Project
**East West Rail
(Western Section)
Phase 2**

Drawing Title
**PASSING PLACE A2_P_2
GENERAL ARRANGEMENT**

Stage 2 Road safety audit response report

Offline Highways Passing Places – Package 2 – Oxfordshire (A3 Marsh Gibbon – Compound Access)

PASSING PLACE A2_P_2 EXISTING UTILITIES AND SITE CLEARANCE

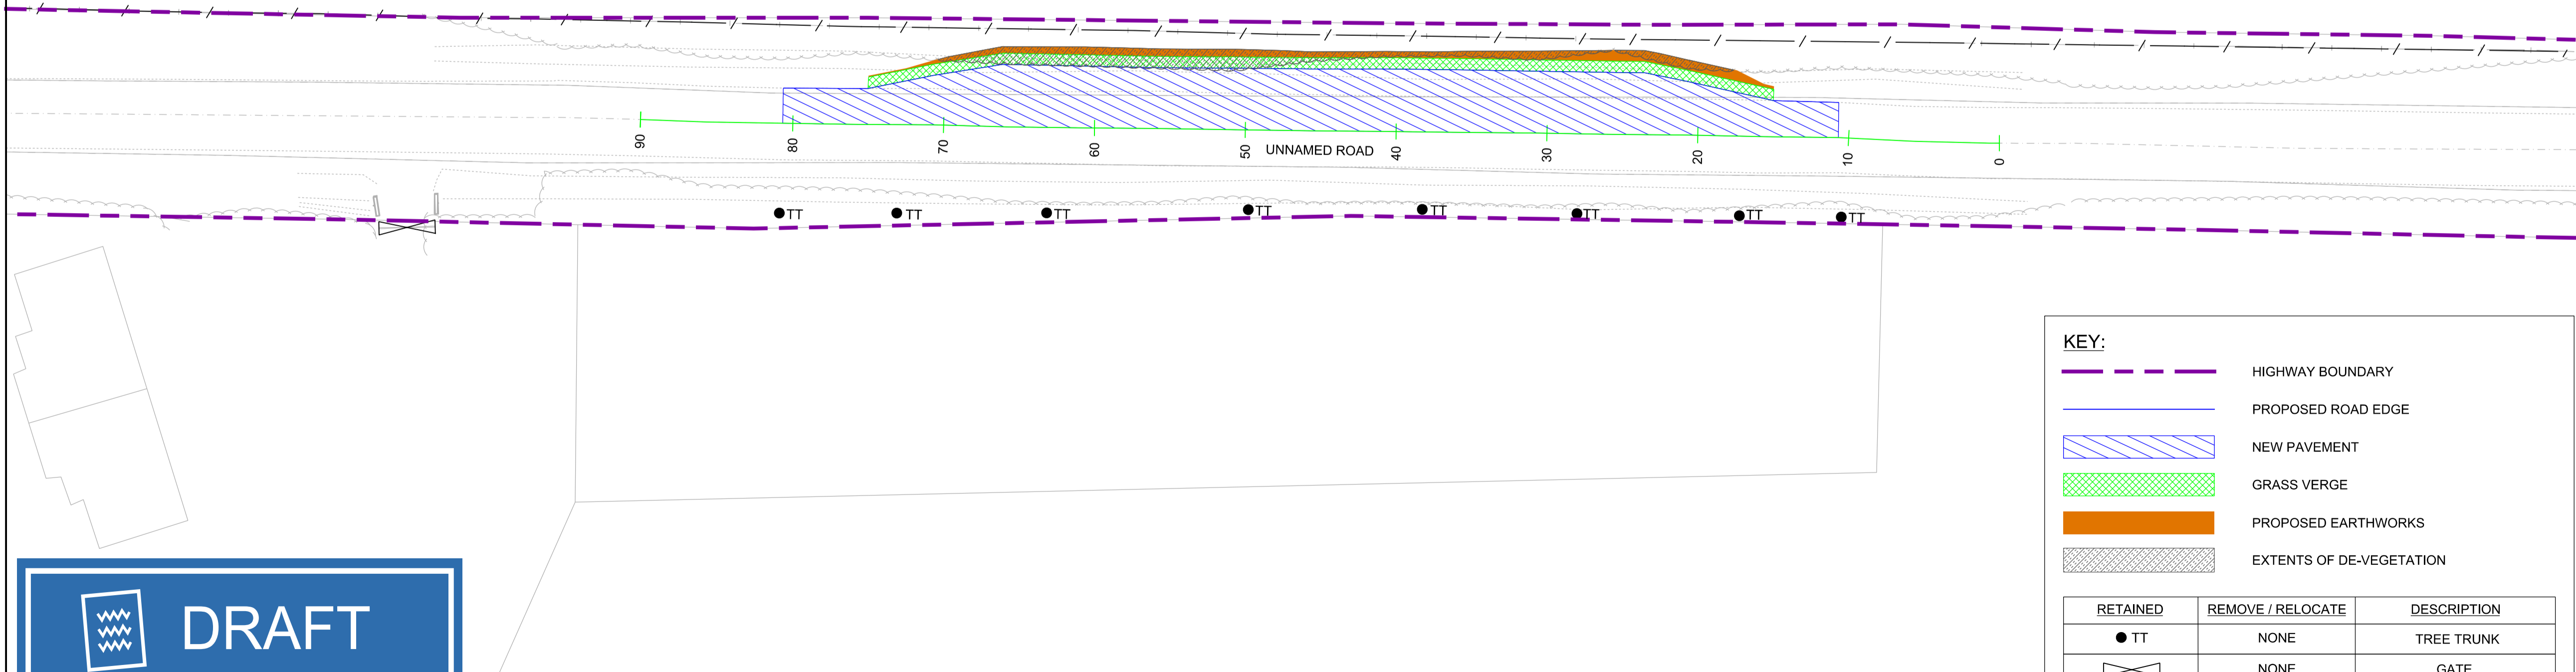
Summary: Driver visibility reduced by vegetation

Passing places are proposed in positions where vegetation may restrict drivers' visibility of the route and the visibility of vehicles using the passing places. With this limitation, drivers of construction vehicles may not be aware that they should wait and might proceed, increasing the risk of side swipe collisions, or the risk of vehicles leaving the carriageway

on narrower sections of carriageway. Additionally, drivers of approaching vehicles may not anticipate the construction vehicle leaving the passing place, leading to side swipe or head on collisions.

There is further risk that existing vegetation will encroach into the carriageway increasing the risk of damage to vehicles and HGVs being pushed towards oncoming traffic.

The existing vegetation should be cut back to ensure clear visibility to all traffic signs and to keep the carriageway clear from obstructions.

2.5	<p>Passing Places A2-P-2, A3-P-2, A3-P-3, A3-P-4, A3-P-5, A3-P-6, A3-P-7, A3-P-8, A3-P-9 and A3-P-10. Unnamed Road (towards Mill Road) and Unnamed Road.</p>	<p>Driver visibility reduced by vegetation Passing places are proposed in positions where vegetation may restrict drivers' visibility of the route and the visibility of vehicles using the passing places. With this limitation, drivers of construction vehicles may not be aware that they should wait and might proceed, increasing the risk of side swipe collisions, or the risk of vehicles leaving the carriageway on narrower sections of carriageway. Additionally, drivers of approaching vehicles may not anticipate the construction vehicle leaving the passing place, leading to side swipe or head on collisions. There is further risk that existing vegetation will encroach into the carriageway increasing the risk of damage to vehicles and HGVs being pushed towards oncoming traffic.</p>	<p>The existing vegetation should be cut back to ensure clear visibility to all traffic signs and to keep the carriageway clear from obstructions.</p>	<p>Accept the RSA problem and recommendation made by the RSA team. The site clearance drawings include vegetation clearance to achieve required visibility and signage strategy drawings likewise include this provision.</p>	Accepted	Proceed as Design Team Response
